Delegated Report

Householder Planning Application

Planning Application No: 20240568

Description: Raising of ridge height and construction of 2no. dormers on side/rear roof slopes, to facilitate the conversion of the loft into habitable space, along with associated external alterations.

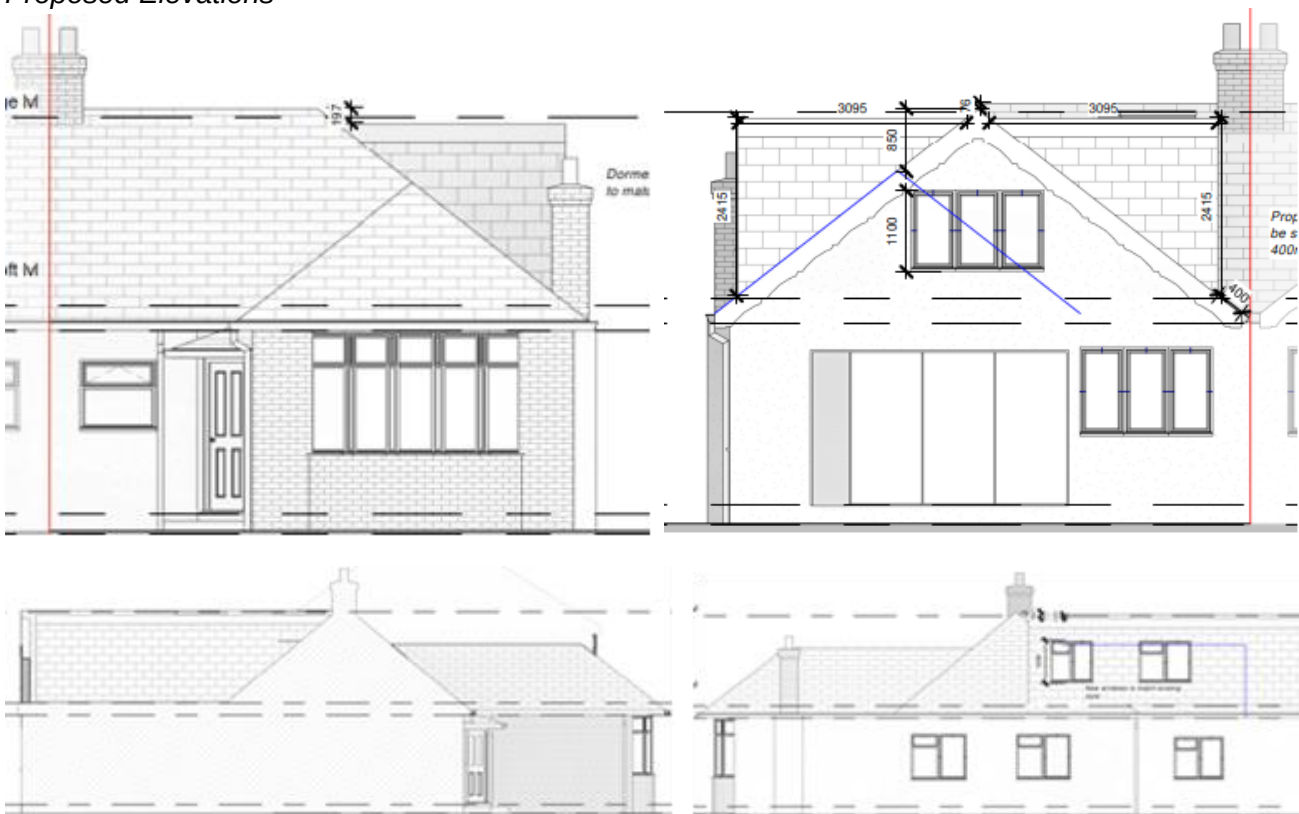
The rear roof ridge height would increase from 4.69m to 5.61m, an increase of 920mm. The dormers would be box dormer design and would measure 8.16m in width from the middle ridge line, be 2.43m in height and project from the side roofslope by 3.45m for the north facing dormer and 8.38m for the south facing dormer. This would also result in the roof and proposed dormers extending above the existing flat roof rear projection.
